HGY/2024/0073: 27 Aylmer Road

Highgate Conservation Area Advisory Committee objects to this application on the following grounds:

4. Daylight/sunlight studies for bedroom in basement required

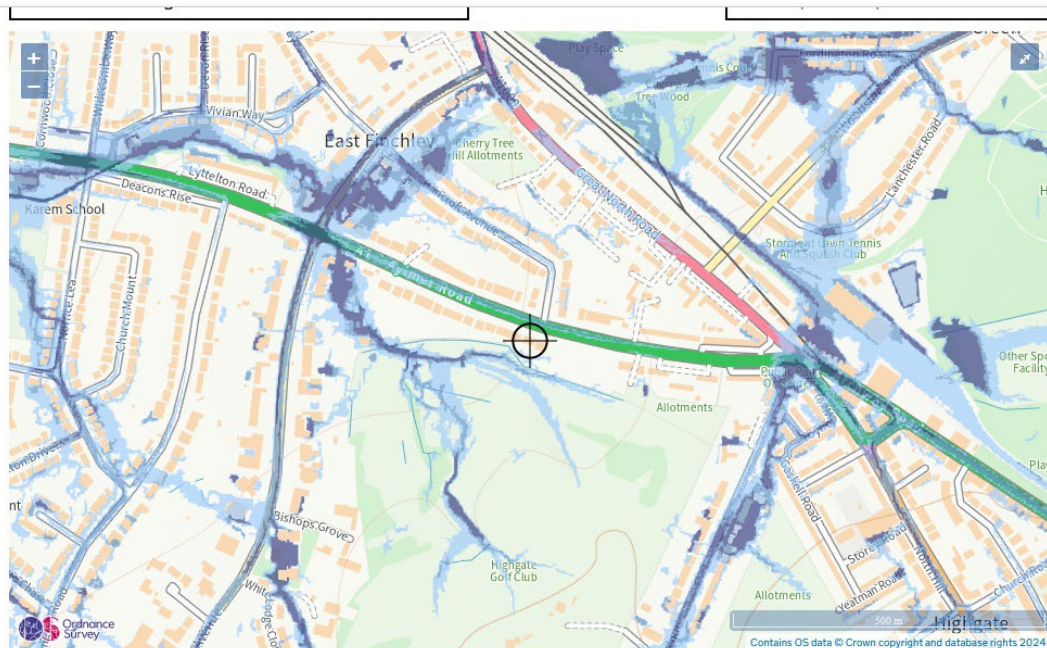
This bedroom may be used by staff who would require appropriate levels of daylight and sunlight as it would probably be a bed-sitting room. The outlook would in any case be poor. (see also Ground water and flooding below)
